TIE-LINE 637 WOOD-TO-STEEL PROJECT
MINOR PROJECT REFINEMENT
REQUEST FORM

Date Requested:	June 6, 2014	Report #:	009
Date Approved:	June 10, 2014	Approval Agency:	No other agency approval is required.
Property Owner(s):	Private and SDG&E Right-of-Way (ROW).	Location/Milepost:	P161
Land Use/Vegetative Cover:	The proposed impact area occurs primarily within disturbed grassland habitat.	Sensitive Resources:	Sensitive habitats including native and non-native grassland and oak savannah habitat.
Refinement / Modification From (check all that apply):			
<input type="checkbox"/> Permit	<input type="checkbox"/> Plan/Procedure	<input type="checkbox"/> Specification	<input type="checkbox"/> Drawing
<input checked="" type="checkbox"/> Other: Revised Overland Travel Route to Structure No. P161.			
San Diego Gas & Electric Company (SDG&E) is proposing to utilize a different overland travel route to Structure No. P161 than what was originally described within SDG&E's application for a Permit to Construct (PTC) for the TL 637 Project (refer to Proponent's Environmental Assessment [PEA] Appendix 3-B) and the Final Initial Study/ Mitigated Negative Declaration (IS/MND) (see Figure 1 and refer to MND

Figure 1: MPR Overview Map showing the original overland travel route (yellow line) to P161 from Highway 78.

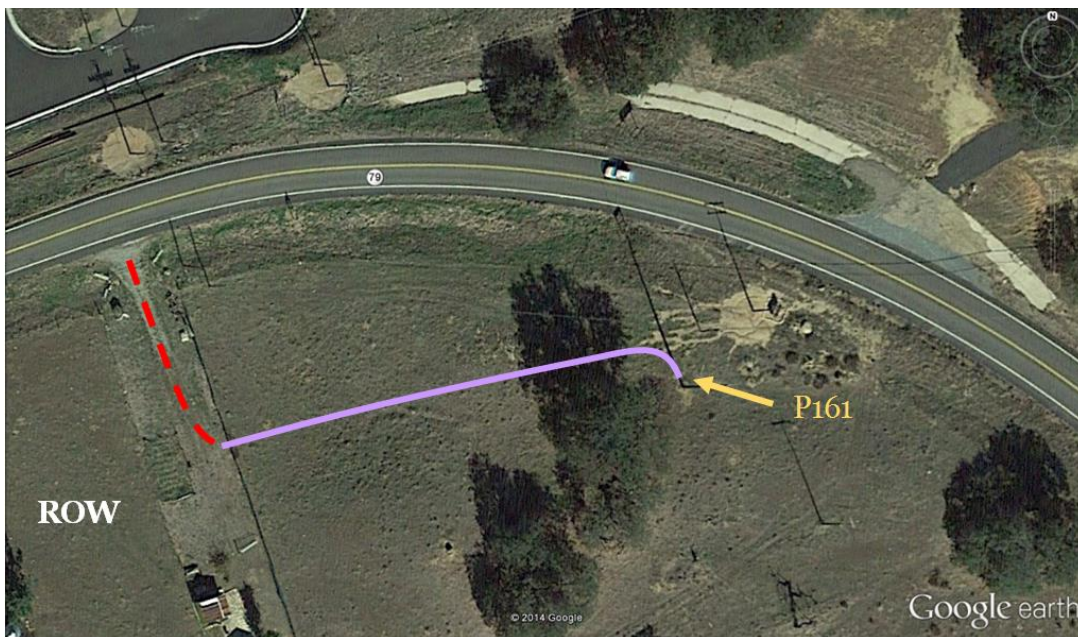
Description of Refinement			
SDG&E proposes to use a different overland travel route to Structure No. P161 in order to safely and successfully conduct construction activities. The proposed refinement would shift the overland travel to the west of Structure No. P161 so that access will be via an existing private access road and not directly from State Route (SR) 78 (see Figure 2).			
The proposed shifted overland travel route to access Structure No. P161 is approximately 280 feet long by 14 feet wide, and will result in approximately 3,920 square feet of temporary impacts to disturbed grassland habitat. Figure 2 depicts the proposed new overland travel route. Photograph Nos. 1 and 2 depict the existing private road and entrance from SR 78, and proposed overland travel route to Structure No. P161, respectively.			
Original Condition:			
The originally anticipated overland travel route to Structure No. P161 connected to the structure site from the north via SR 78 (refer to Figure 1) and was approximately 135 feet in length and was located within disturbed grassland habitat.

Justification for Change:			
Following in-field review of the proposed overland travel route, construction crews identified safety concerns with utilizing the originally planned overland travel route (refer to Figure 1) from SR 78. The modified overland travel route is advantageous over using the existing route location because it is safer for construction personnel to enter the pole location via the overland travel route from the private access road.
